RE: Clean Harbors Lone Mountain, LLC  
Lone Mountain Facility  
Waynoka, Oklahoma  
EPA ID No. OKD065438376  
Response to Technical Review – Notice of Deficiency  
Class 3, Tier III Permit Modification Request – Landfill Cell 16 Engineering Report

**Subject: Response to Technical Review - Notice of Deficiency  
Class 3, Tier III Permit Modification Request  
Landfill Cell 16 Engineering Report  
Lone Mountain Facility  
Waynoka, Oklahoma**

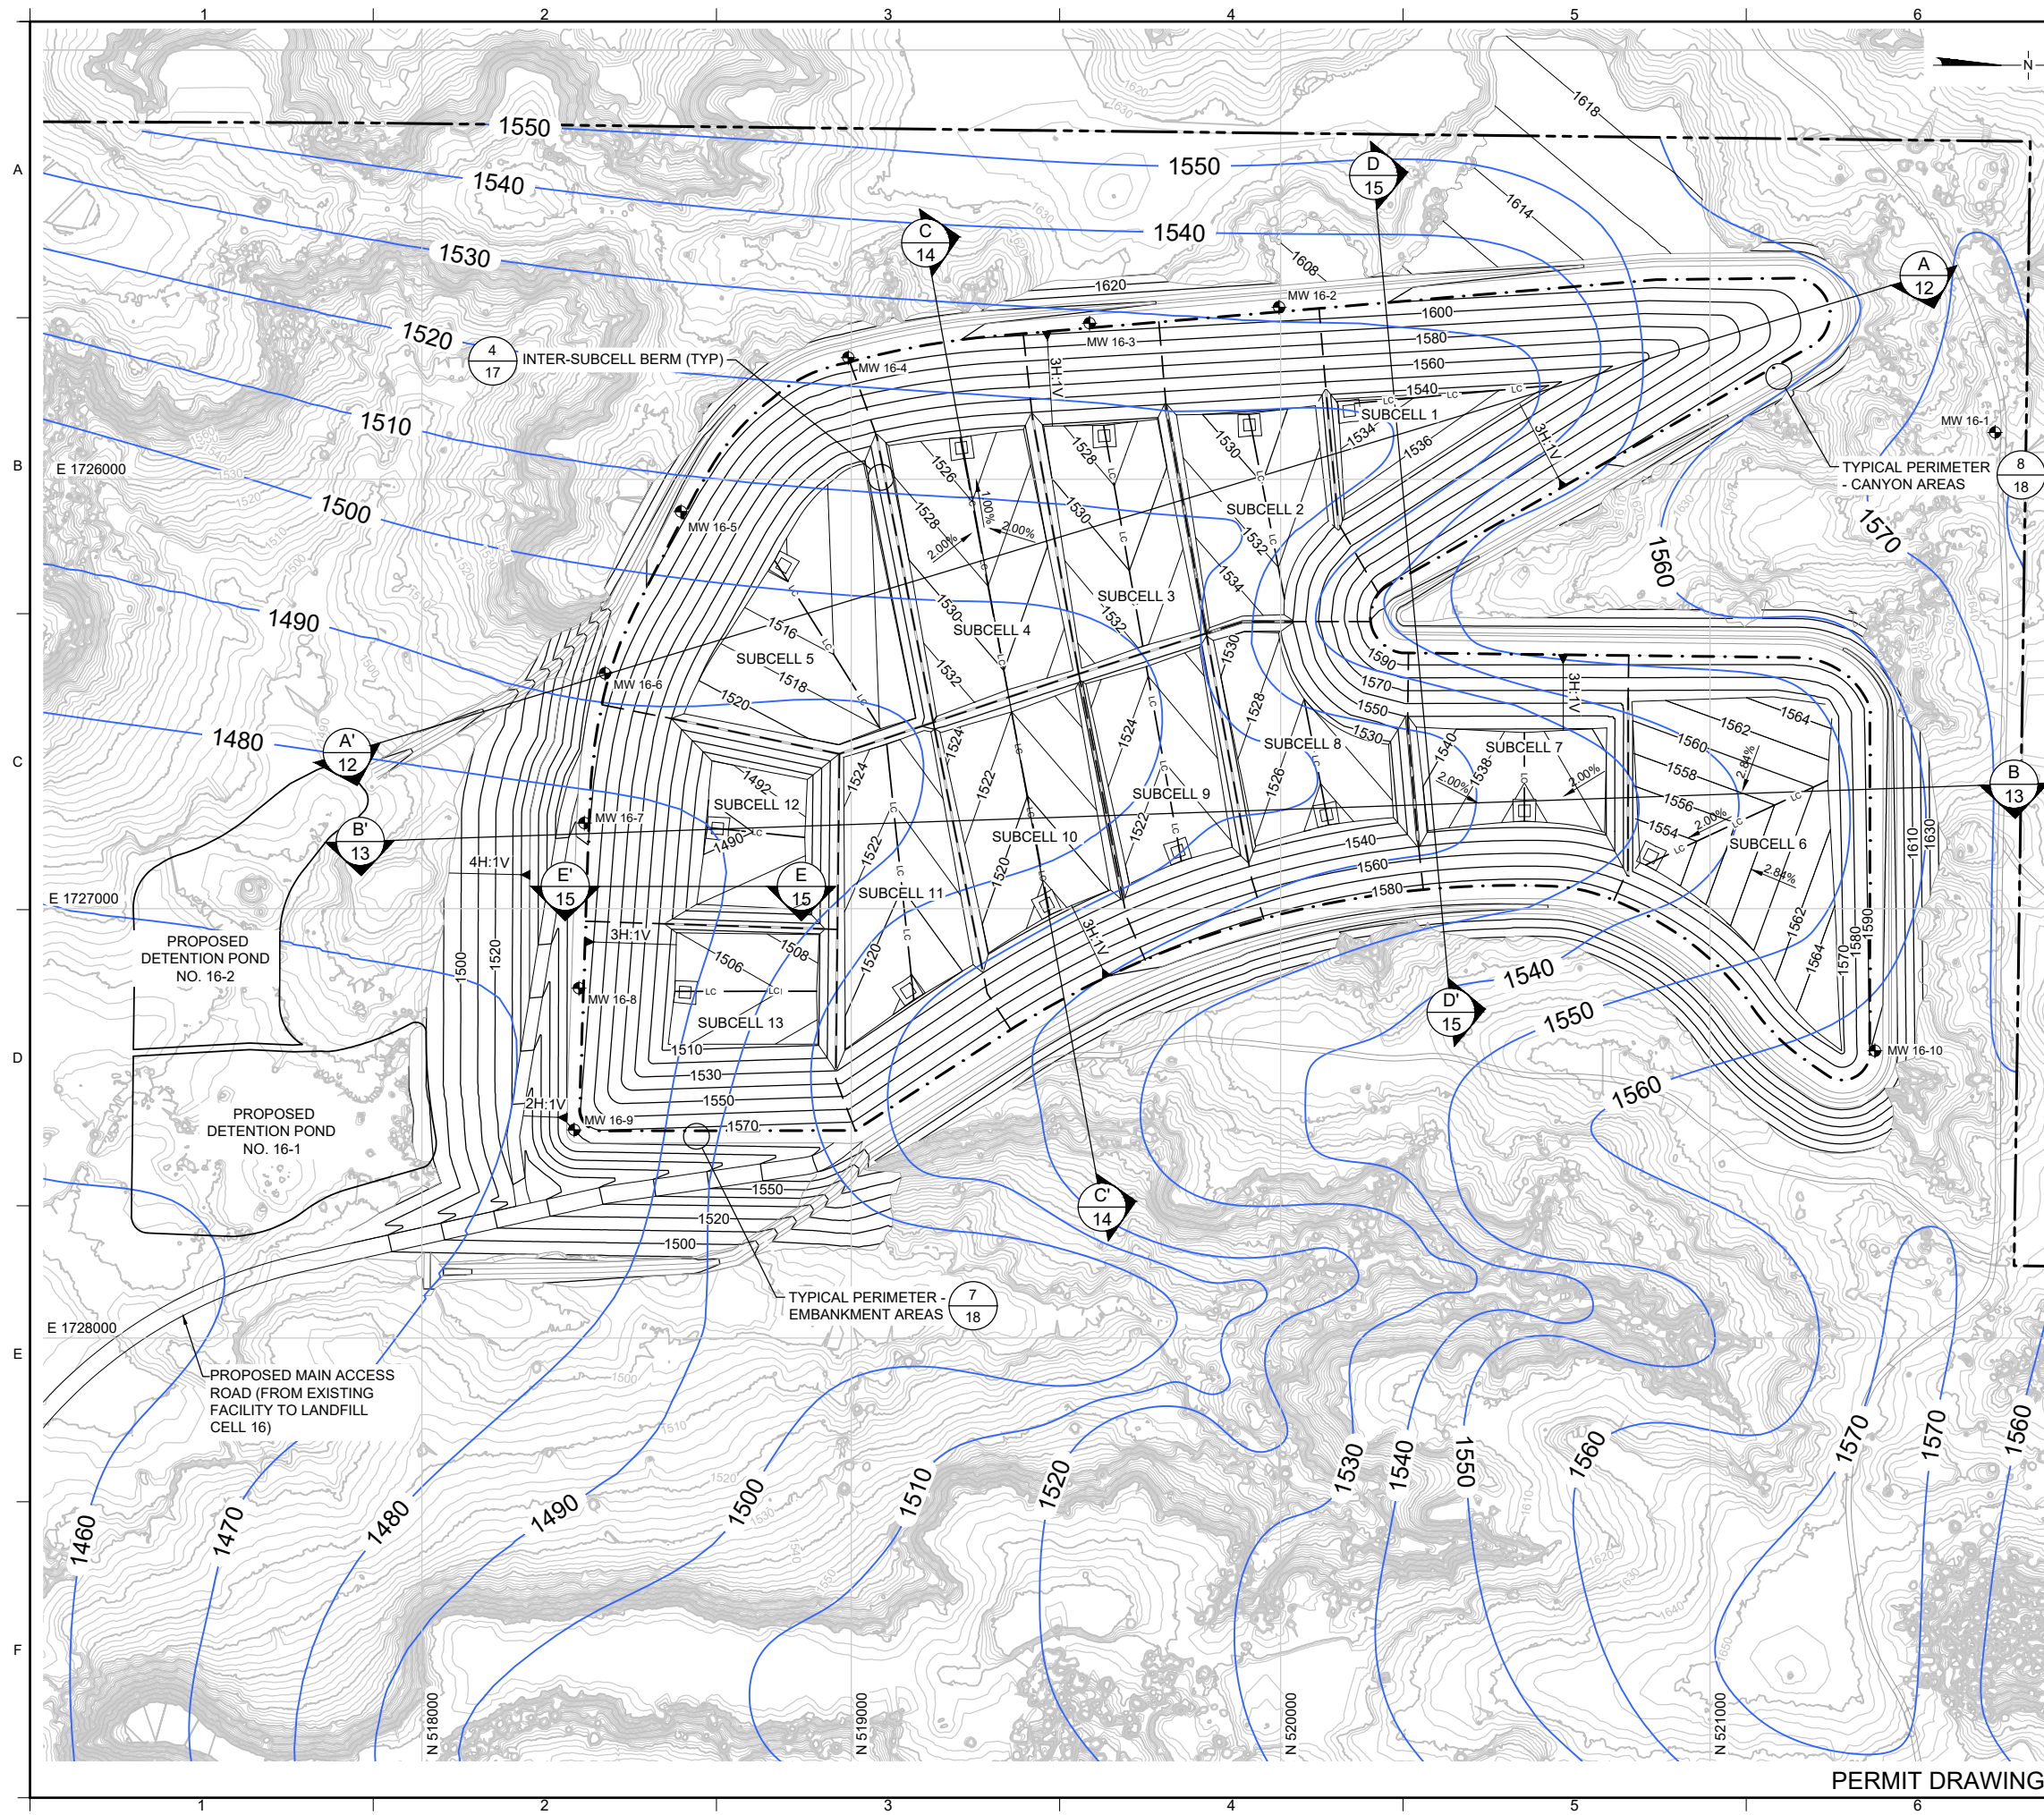
*Comment 5: Please include the groundwater contours with a different format/color in Drawing 5 of 26 – Overall Cell 16 Top of Clay Liner Grading Plan of Exhibit A to be able to evaluate the 5-feet of separation from groundwater at the Sub-Cell sumps.*

Response to Comment 5: Drawing 5 of 26 has been revised as requested. We have also revised Drawing 1 (Title Sheet) to reflect the revision dates on the drawing index (list of drawings).

SEASONAL HIGH GROUNDWATER TABLE COUNTOUR MAP TAKEN FROM DRAWING 4. SEE DRAWING 4 NOTE 3 FOR ADDITIONAL DESCRIPTION OF DATA SOURCES AND MAPPING BASIS.

**WELL DESIGN INFORMATION - DETECTION MONITORING WELL NETWORK  
LANDFILL CELL 16, LONE MOUNTAIN FACILITY**

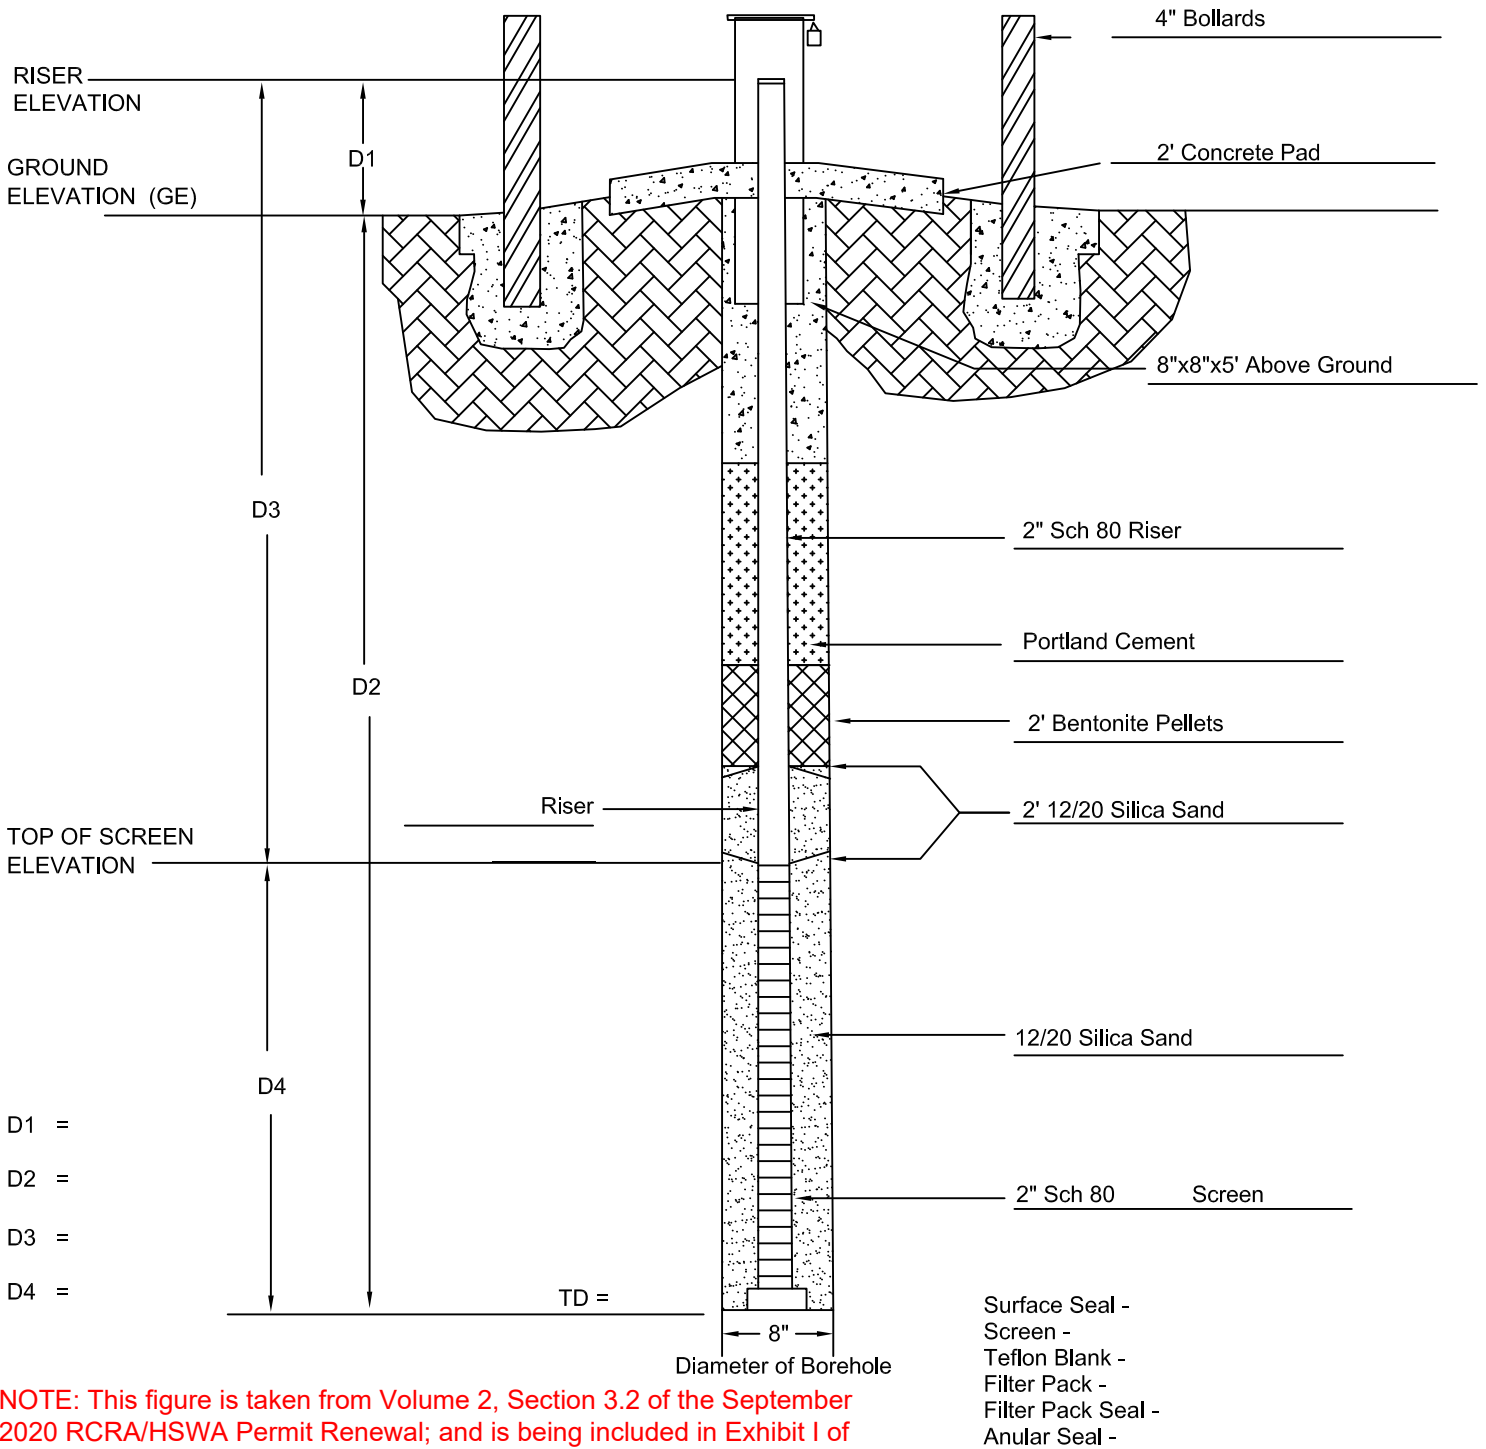
*Comment 4: Please provide monitoring well construction diagrams and anticipated depths for the Cell 16 groundwater monitoring well network. Construction of monitoring wells should be consistent with the requirements of the Oklahoma Water Resources Board.*

Response to Comment 4: A table of design information showing the anticipated depths of each monitoring well, along with a monitoring well construction diagram, has been added as requested. This is provided as a brief narrative in new Section 7 of the Engineering Report, plus the addition of “Exhibit I” where tabulated well design information and a typical well construction diagram is included.
